Urban Design Changes

Pearl Lofts

12.14.21

Relation with Future TXDOT Improvements

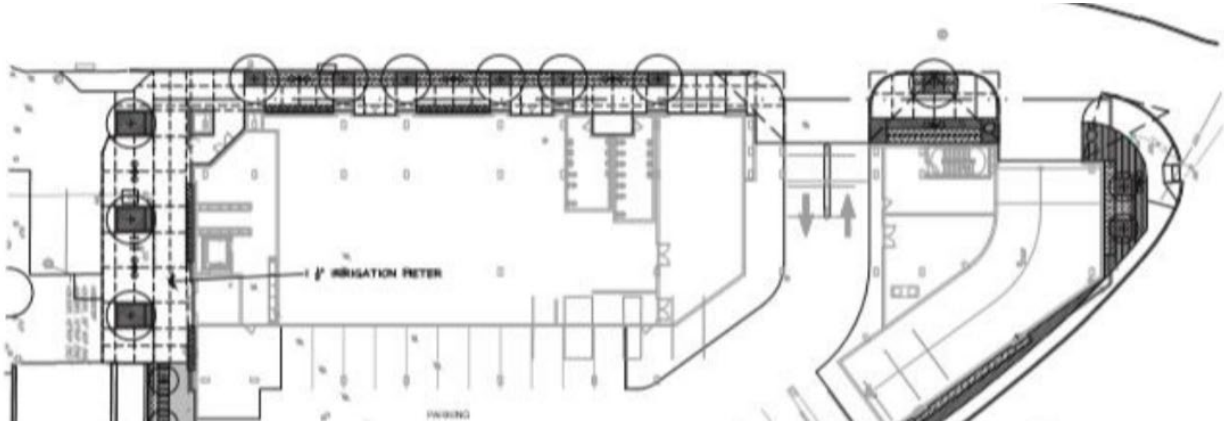
2. The Panel recommends that more thought be given to the way this development interfaces with the removal of Cesar Chavez, including providing a potential Phase II diagram. Another possibility is a future extension of the proposed garage to allow for new retail/office along the Pearl Street frontage.

- As a part of the second review, the Panel advised the development team better consider ways in which this development could be thought of as part of future development which could occur as a result of the reconstruction of I-30 and the freeing up of City and TXDOT right-of-way. The development team provided a diagram highlighting what that might look like in the future.

Before: Initial site plan

After: Diagram showing how Pearl Lofts might interface with new developable property

Streetscape and Plaza Enhancements Along Jan Pruitt Way

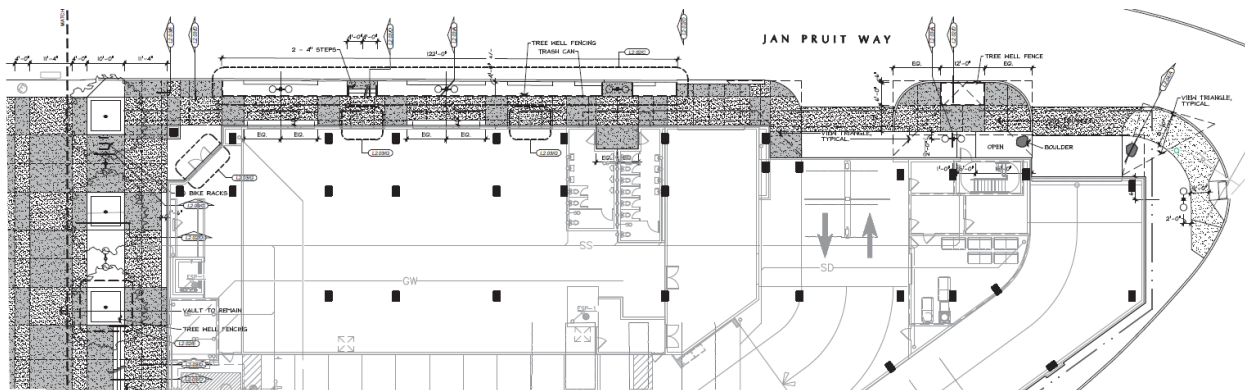
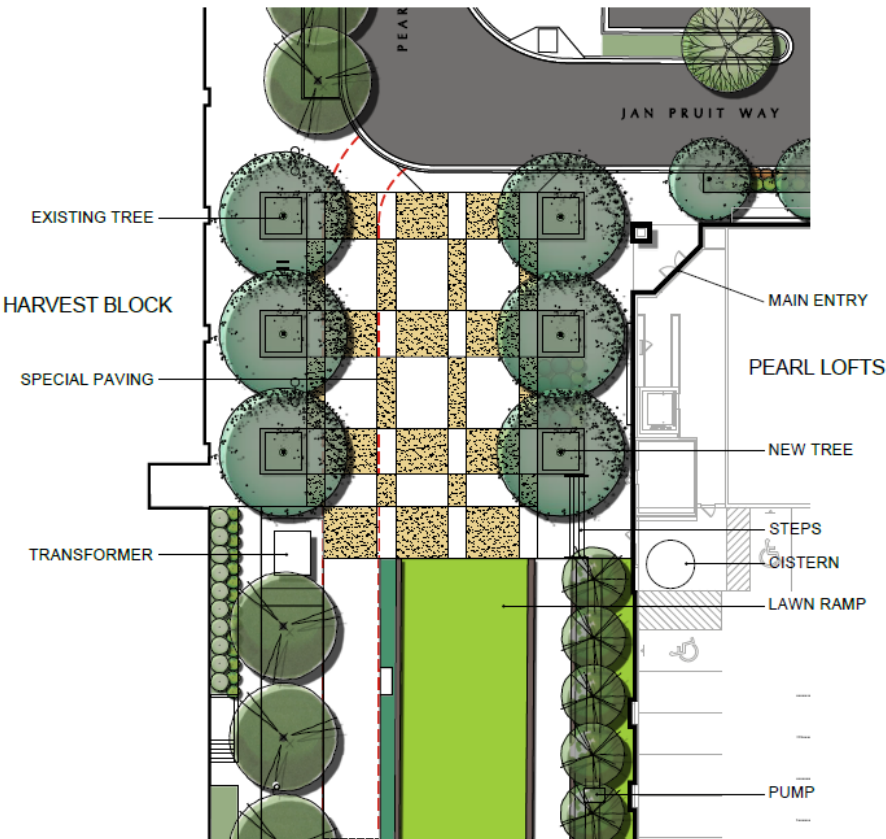
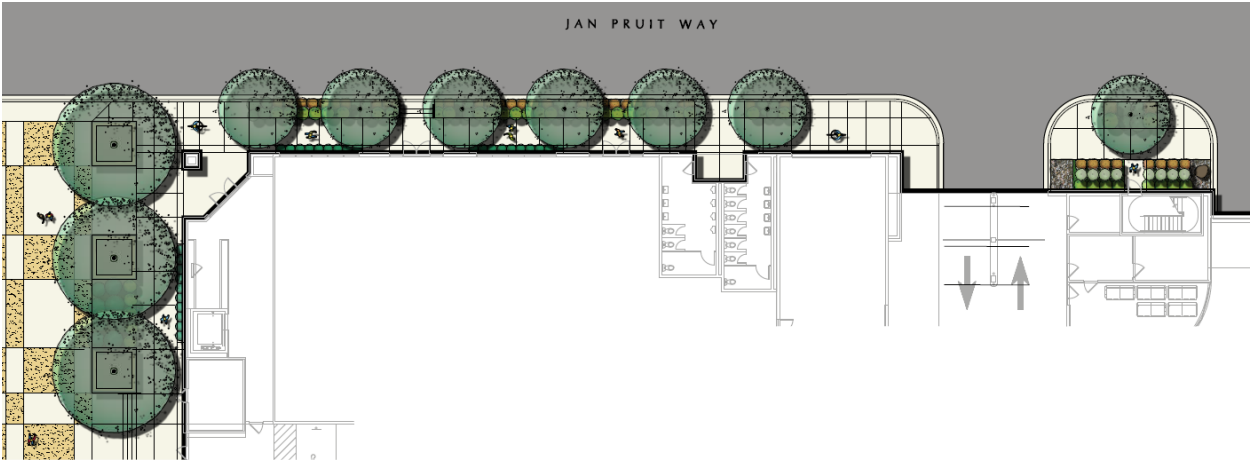
5. The Panel recommends further design detail be given to the plaza space between the Harvest Lofts and Pearl Lofts, advising a new location for a dog park/relief area might be warranted. Consideration should also be given for the terminating lawn to be used for integrated stormwater management and underground storage opportunities.

6. The Panel recommends that further design refinement be given to the streetscape along Jan Pruitt Way to create a more inviting pedestrian space, including replacing the landscape buffer with tree wells and giving more focused design to the driveway entries into the garage.

3. The Panel advises that the design consider stormwater management and processing along the edge of the site to improve water quality.
4. The Panel recommends further design detail be given to the streetscape and façade along Jan Pruitt Way, including widening the sidewalk and enhancing ground-level transparency.

6. The Panel recommends further thought be given to how loading will occur in the proposed plaza, considering the need to treat this as a people-oriented space.

Before: The treatment of the plaza area at the terminus of Pearl Street was not considered. Additionally, the streetscape along Jan Pruitt Way needed improvements in terms of dimensions and treatments across driveway entrances.

After: Improvements were made to the plaza at the terminus of Pearl Street, considering its need to accommodate pedestrians and provide uses such as food trucks but also still need to serve as a loading zone for the Harvest Lofts in the future. Additionally, improvements were made across the site's two driveways to create one uniform pedestrian experience and level.
